Battle Green Improvements/Town Center Streetscape Project

Massachusetts Avenue @ Woburn Street / Winthrop Road / Fletcher Avenue

Board of Selectmen Meeting November 30, 2015

Option 6 - Intersection With Roundabout

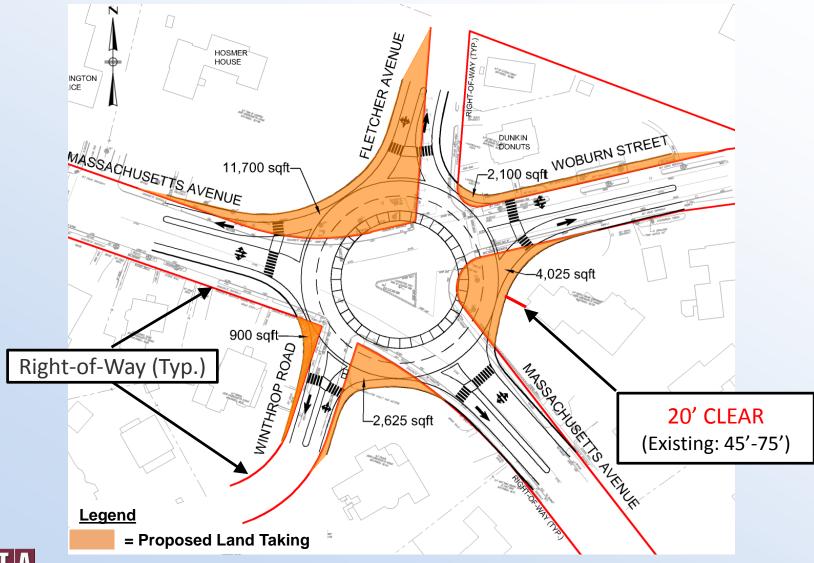
- 10. If a round-about is installed at Woburn, how close would it be to the Russell Square condos? Approximately 20 feet. The current offset ranges between 45' and 75'
- 11. Can the Town lower the speed limit in the Center to 20-25 mph and also add speed monitoring signs? Would like a tutorial on establishing speed limits and what the 85th percentile means.

Crosswalk at Meriam Street

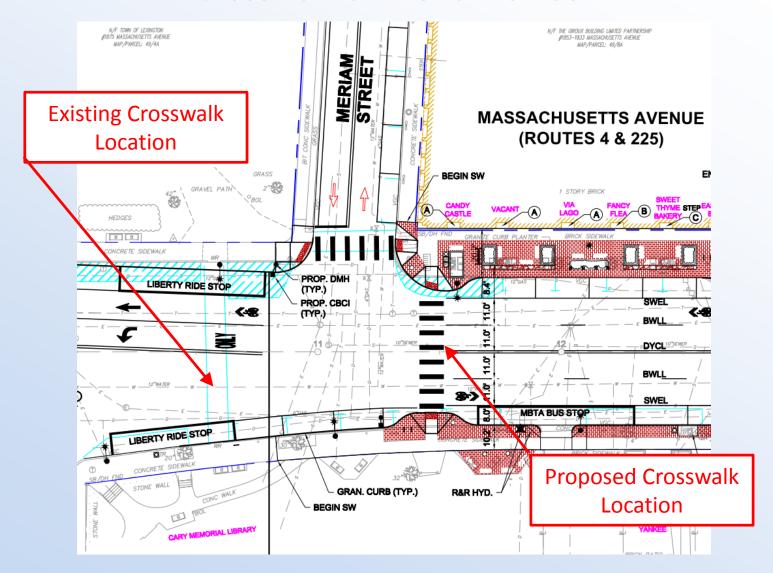
12. How do the engineers decide where to locate crosswalks in the Center?

Crosswalks are located based on the ability to provide a safe crossing and pedestrian desire lines. A pedestrian desire line is a path that represents pedestrian's desired route between an origin point and a destination point. A good example is the crosswalk located on Mass Ave at Meriam Street.

Delay Times and Vehicle Queues – AM Peak Hour

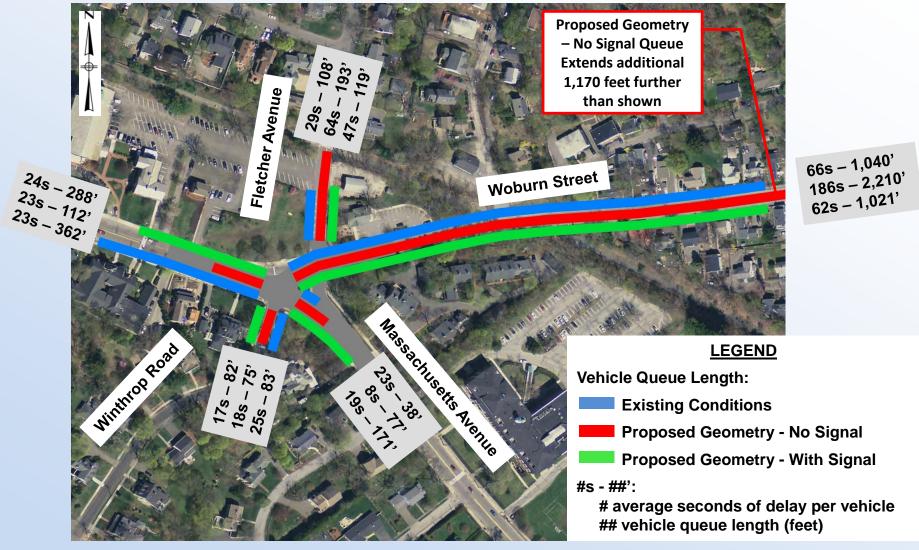
18. What is the wait time versus the queue under the different scenarios?

A summary of the delay times and queue lengths is provided on the next two slides.
